Planning Commission Work Session Agenda

Project Number	WVR 57693 & LSD 57496
Applicant	Cody Sexton
Address/Location	AR HWY 94/340
Current Zoning	N/A: Planning Area
Site Area	2.63 acres
Nature of Request	Seeking a waiver of 107-317(e)&(f) and proposing a Dollar General.

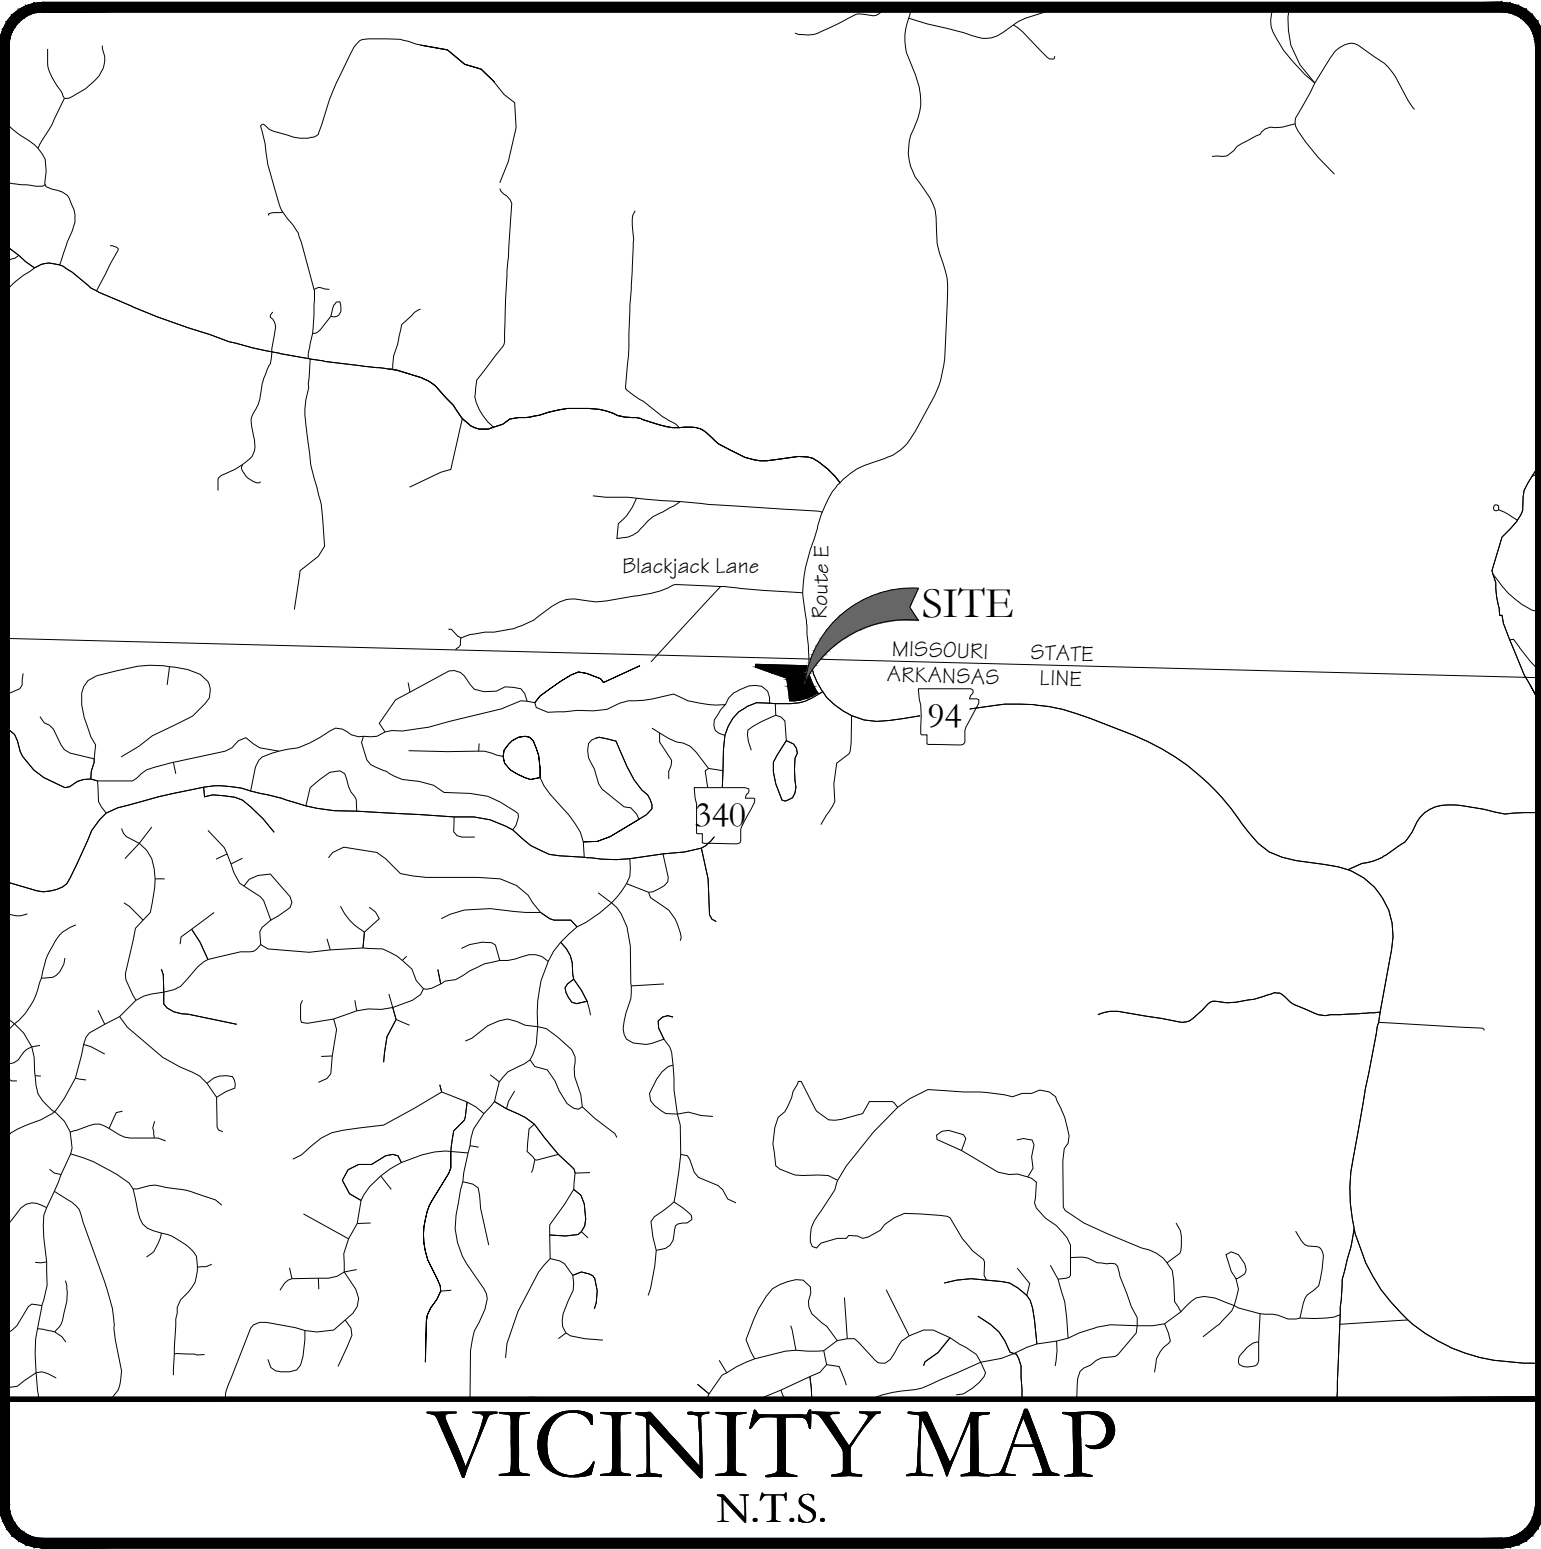
2. Provide measurement of throat length (edge of asphalt to edge of first parking spot.)

Response: Updated on Sheet C1.

SHEET NUMBER: C2

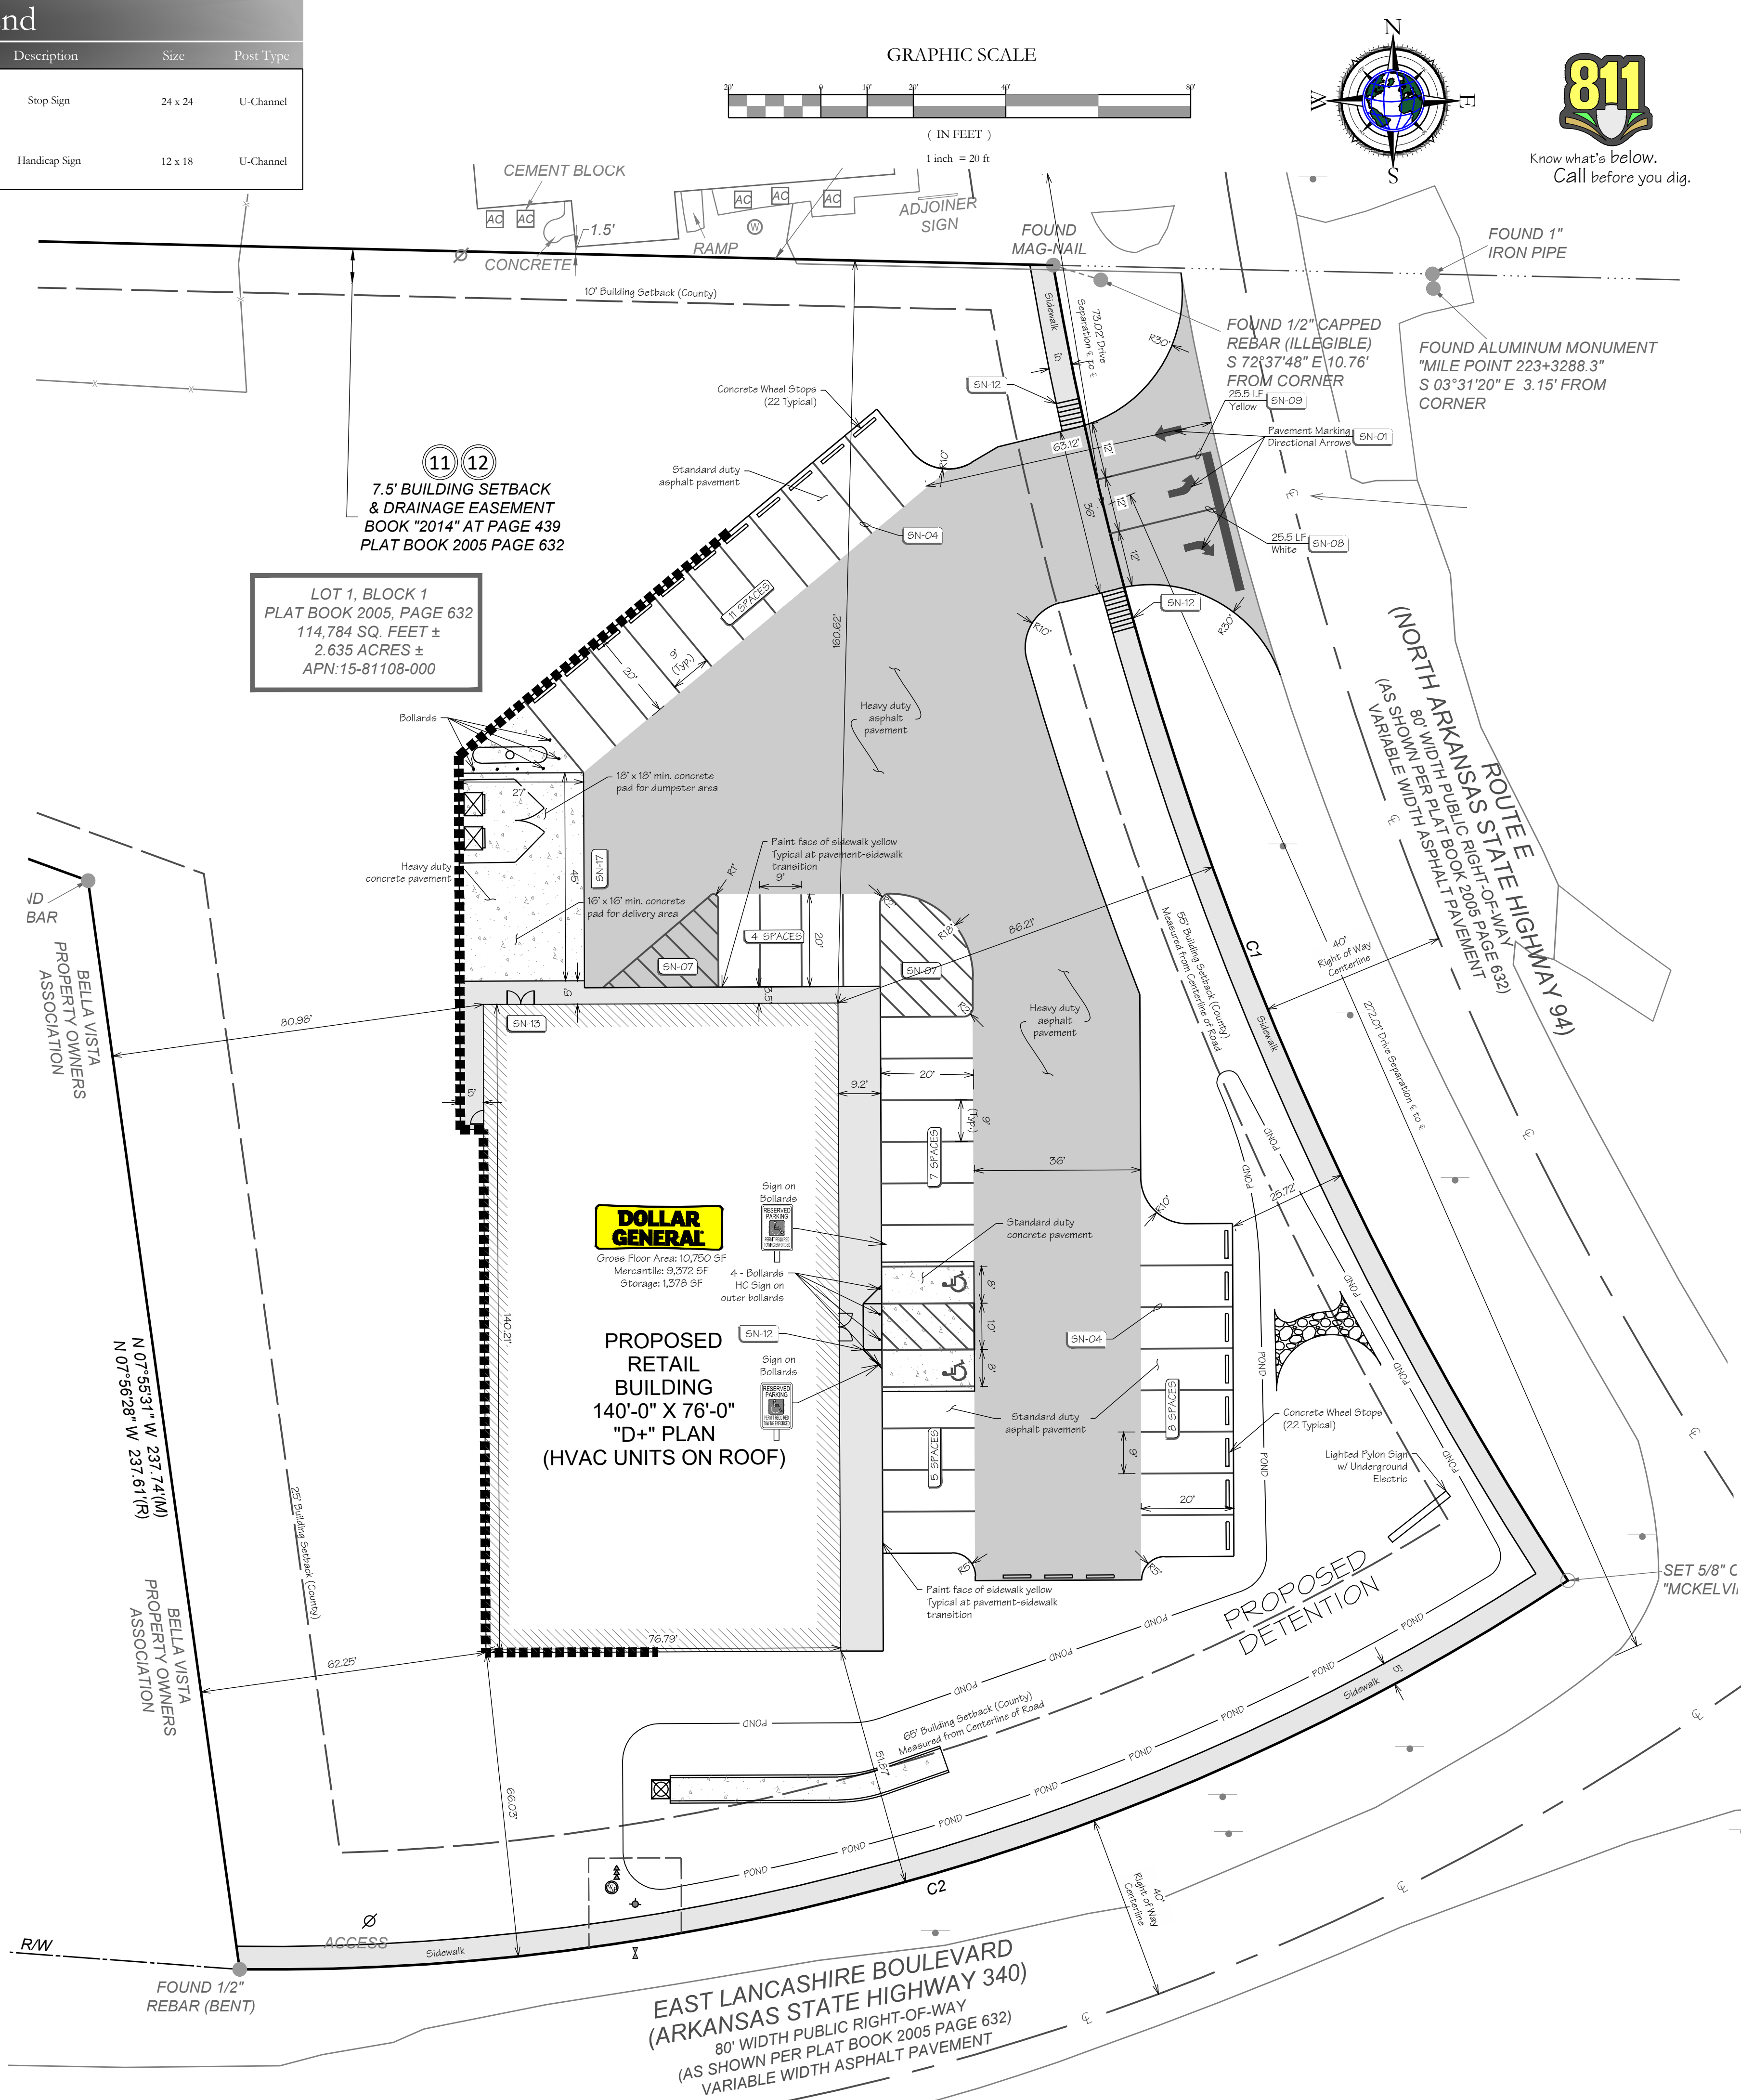
11. Show street right of way line clearly labeled. The drawing shall depict any future ROW needs as determined by the AHTD and master street plan. Future ROW as well as existing ROW and centerlines should be shown and dimensioned.

17. Show the location of all existing structure. On Large Scale Development, show location of proposed buildings and square feet. Dimension building and setbacks from the building side to property lines.

Turning radii for access drives to properties adjacent to collector, minor arterial, or major arterial streets, as identified on master street plan, shall be at least 30 feet. Exceptions may be granted through a waiver to the planning commission for larger radii needed where there may be a need to accommodate truck traffic.

3. Fix the building setbacks. Showing from the centerline instead of the property line.

Response: Additional dimensions have been added to Sheet C2 to indicate ROW width to the

Response: Additional dimensions have been added to Sheet C2, measuring the building corners to the nearest property line.

Response: Driveway turning radii have been increased to 30', and area dimensioned on sheet C2.

Response: Building setbacks as shown were per the requirements of Benton County, as this particular site is under the jurisdiction of both Bella Vista and Benton County. Benton County required their setbacks be dimensioned from the centerline of the right of way. This has been noted and clarified on the plans on Sheet C2.
